# Groundwater Transfer Review Summary Form

Transfer/PA # T- 14303

Application: T-14303

Applicant Name: Deming Ranch Land and Cattle, LLC

## Transfer Review Map

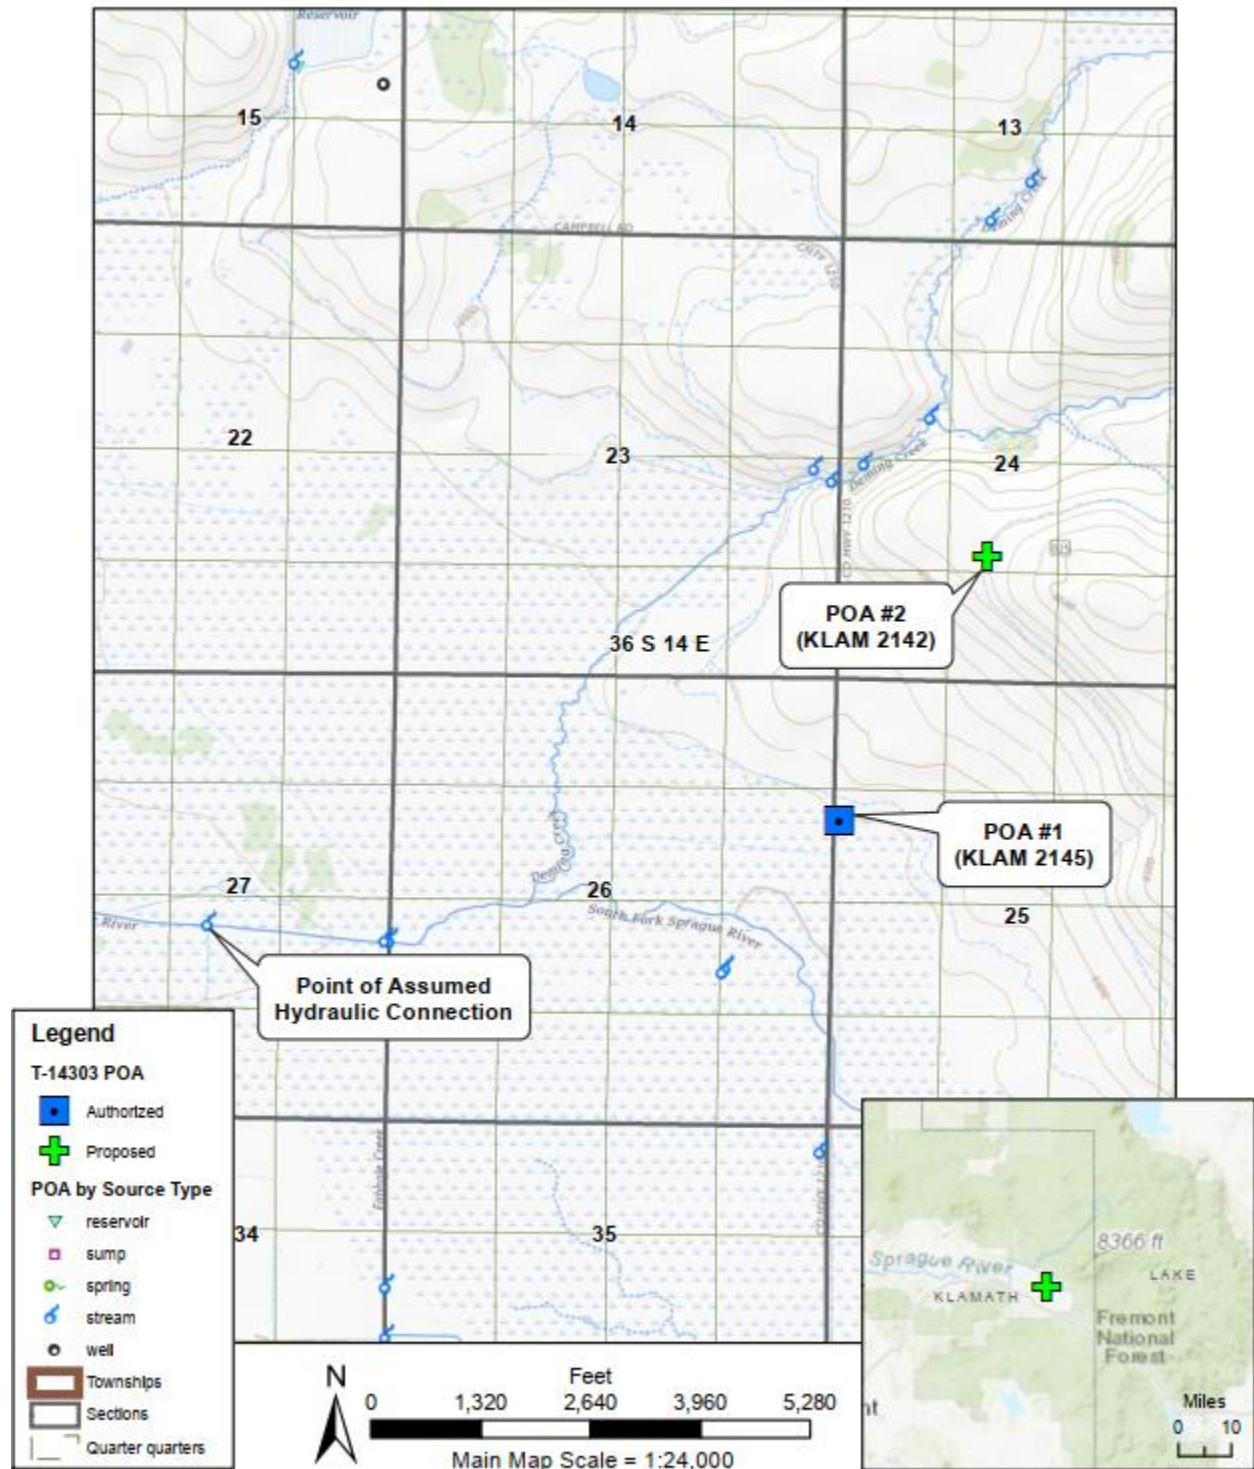
- 
1. Basic description of the changes proposed in this transfer: The applicant proposes to transfer POU and POA for 71.2 acres associated with **Certificate 91239** from authorized **POA #1 (KLAM 2145)** to proposed **POA #2 (KLAM 2142)**. **KLAM 2142** is an authorized POA for **Certificate 83235**.

2. Will the proposed POA develop the same aquifer (source) as the existing authorized POA?  
☒ Yes ☐ No Comments: Both the authorized **POA #1 (KLAM 2145)** and proposed **POA #2 (KLAM 2142)** develop water from the aquifer hosted in the volcanic rocks ("basalts") of the Early Winema Volcanic Field (Sherrod and Pickthorn, 1992). The wells exhibited similar groundwater elevations (within 5 feet) when measured on October 28, 2015 (OWRD GWIS).

4. a) Will this proposed change, at its maximum allowed rate of use, likely result in an increase in interference with **another ground water right**?  
☐ Yes ☒ No Comments: The are no senior groundwater POA located within 1 mile of proposed POA #2. The change proposed by this transfer is not expected to result in an increase in interference with another ground water right.

5. a) Will this proposed change, at its maximum allowed rate of use, likely result in an increase in interference with **another surface water source**?  
☐ Yes ☒ No Comments: The closest point of assumed hydraulic connection based on groundwater-surface water elevation to authorized POA #1 is the South Fork Sprague River located ~1.5 miles to the west-southwest. Proposed POA #2 is located ~2 miles from that same point of assumed hydraulic connection. Given the increase in distance from the assumed point of hydraulic connection, it is unlikely that the proposed change would lead to an increase in interference with the South Fork Sprague River.
